SUBJECT: Forwards addl info re schedular commitments for items in draft technical evaluation rept on control of heavy loads.

Re: Turkey Point Units 3 & 4
Docket Nos. 50-250 and 50-251
Control of Heavy Loads
Draft Technical Evaluation Report

Re: Turkey Point Units 3 & 4
Docket Nos. 50-250 and 50-251
Control of Heavy Loads

FIGURE 2a - SAFE LOAD PATH
REACTOR POLAR CRANE UNIT 3

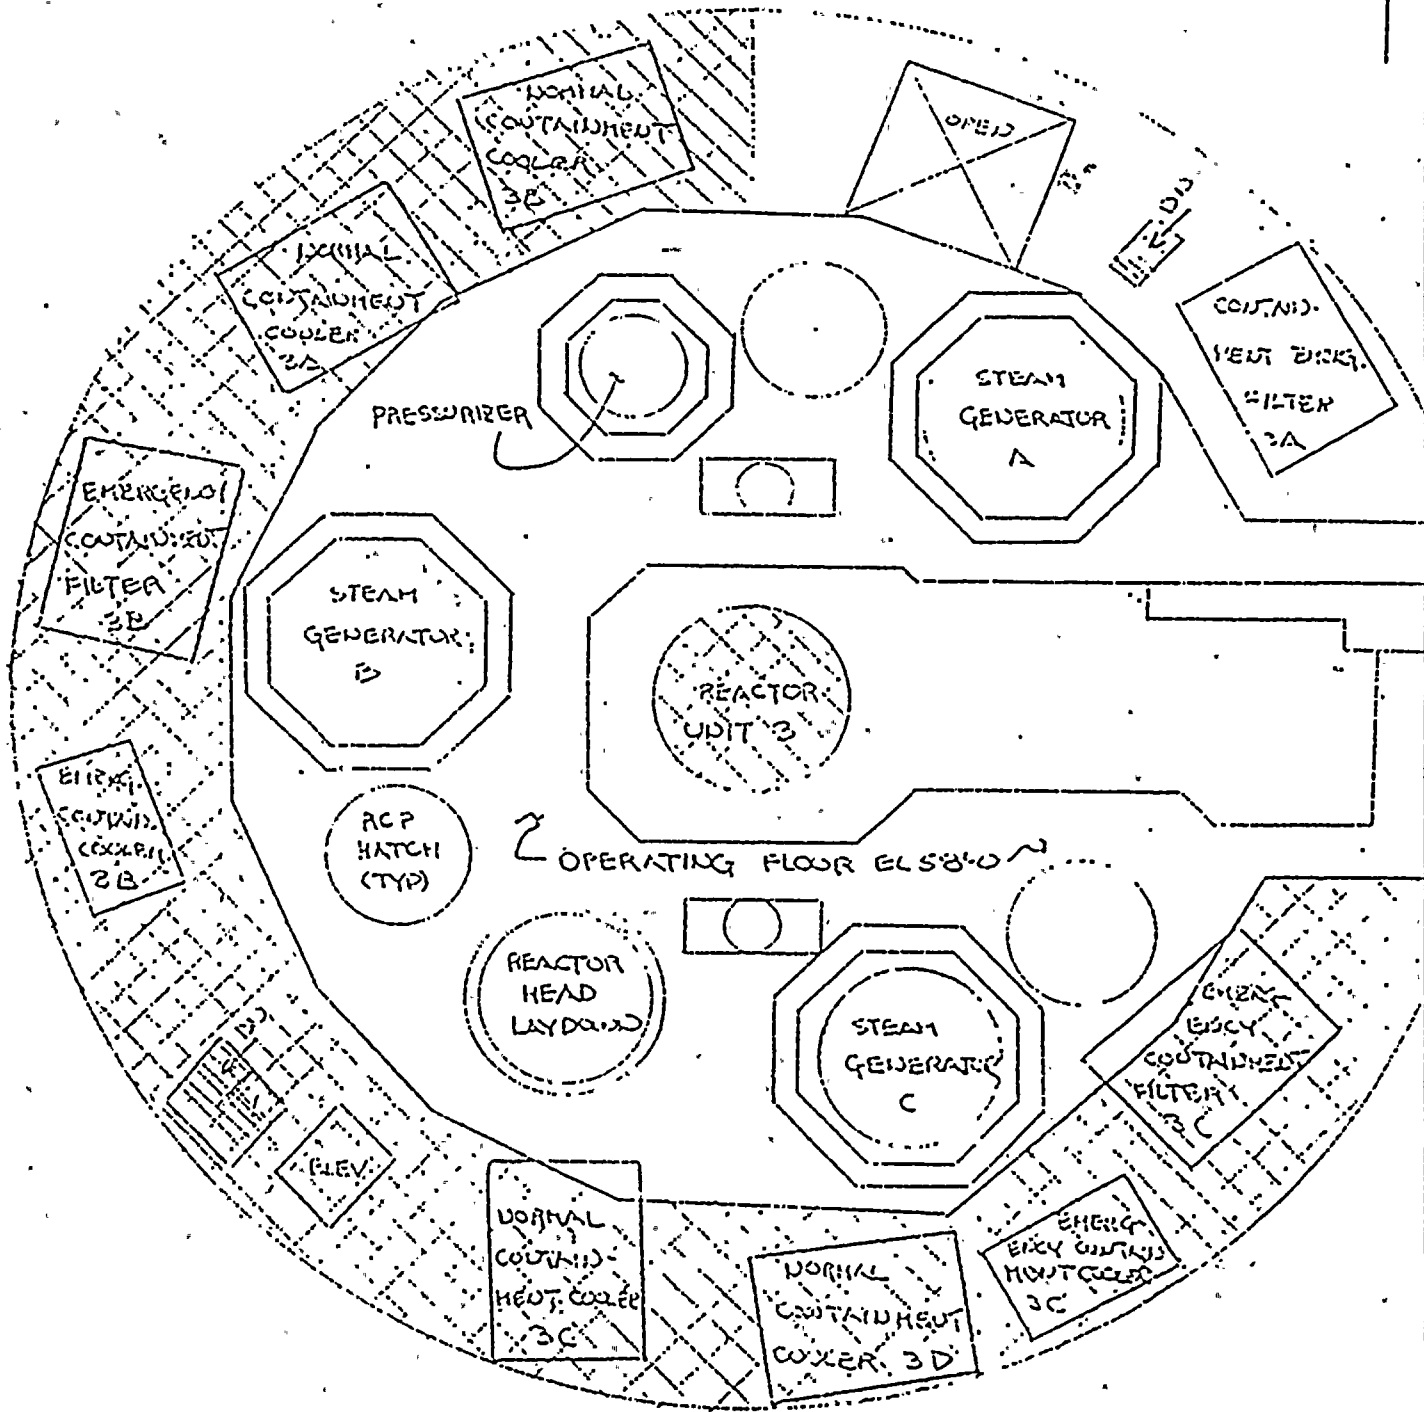
Turkey Point Units 3 and 4 partially comply with Guideline 1. In order to comply with this guideline, the Licensee should perform the following:

1. Define safe load paths where practical. The use of exclusion areas should be limited to miscellaneous maintenance areas and lifts where the designation of individual load paths is impractical.
2. Verify that heavy loads and their safeload paths have been identified in the plant procedure for controlling heavy loads.
3. Verify that the selection of load paths considers the location of structural members and beams.
4. Verify that safe load paths have been clearly marked on floors or structures.
5. Verify that deviations from load paths require written alternatives approved by the plant's safety review committee (or equivalent).

The safe load path areas as defined in the initial response to the NRC generic letter have been revised in a subsequent response to NRC addressing the specific requirements of NUREG-0612. These safe load path areas and restricted zones were developed by the FPL Power Plant Engineering Department. Copies of these safe load path drawings are attached. These drawings indicate certain areas where the handling of loads greater than 1760 pounds is restricted. In some areas the handling of loads greater than 5 tons is restricted. The bases for these restrictions are the different capabilities of the structures in the area to withstand a dropped load and the potential for damage to irradiated fuel and safe shutdown equipment.

Florida Power & Light Company does not concur that marking the safe load paths on the floors or structures is a practical or necessary means of informing the operator of the safe areas. The sketches which are readily available to the operator at the hoist controls, are easy to understand and serve the same purpose as floor markings. Also, floor markings can be obstructed by equipment and are not feasible in certain areas (e.g. the refueling pool).
